LATE COMMENTS

GELSON'S ITEM

PLANNING COMMISSION MEETING

FEBRUARY 8, 2017

ALL NEIGHBORS HAVE LINE OF SIGHT TO PARKING LIGHTS AND ROOFTOP MACHINERY

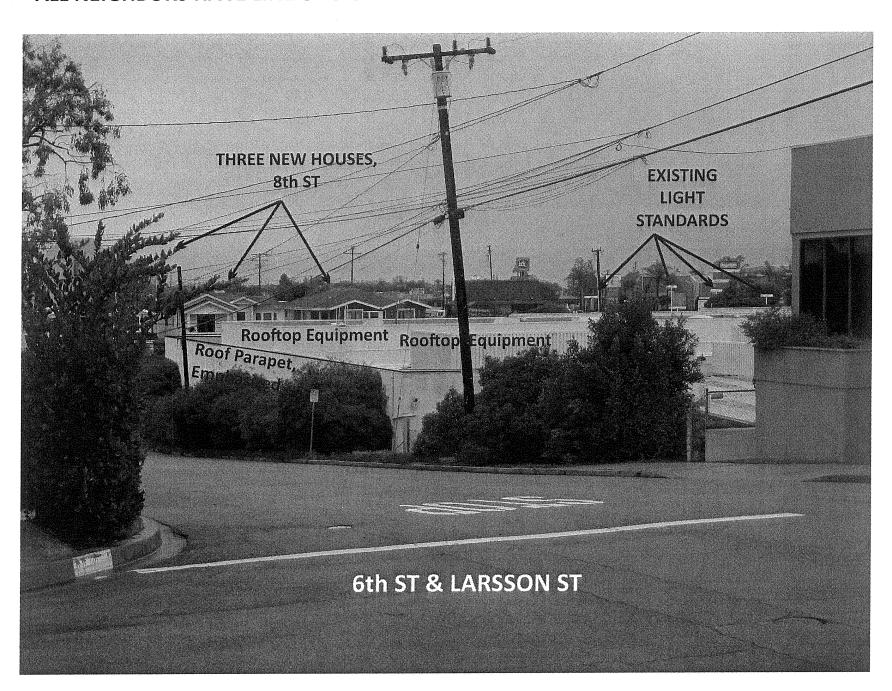
Regarding residential impacts from parking-lot illumination, the initial study incorrectly claims the buildings will shield Larsson St homes from parking lot lighting. [Pg. 49, ¶-3] Per the attached photo, these residences look over the market roof directly at light fixtures. Based on their invalid assumption, Gelson's will give short shrift to the complicated geometry of lighting design, as required by Condition 21 in the draft resolution.

The staff report further confuses the analyses of lighting and noise impacts, by claiming the market building rises eleven feet above the southern portion of Larsson St. [Pg. 13, \P -2] The attached photo shows the market roof lies below the grade of Larsson at 6th St. Thereby, all two-story residences on Larsson and on 8th St will have line of sight to parking lighting and to rooftop equipment.

The attached photo shows that all nearby two-story residences will have direct line of sight to parking-lot lights and to noisy rooftop compressors and fans, of which Gelson's will install many for freezers and coolers.

As seen in the attached photo, Gelson's must design parking-lot lighting that complies with MBMC 10.64.170(c)(2), which requires sharp cutoff of light at property lines. The commissioners should demand proof, not words, how the applicant will shield residents from parking-lot lighting.
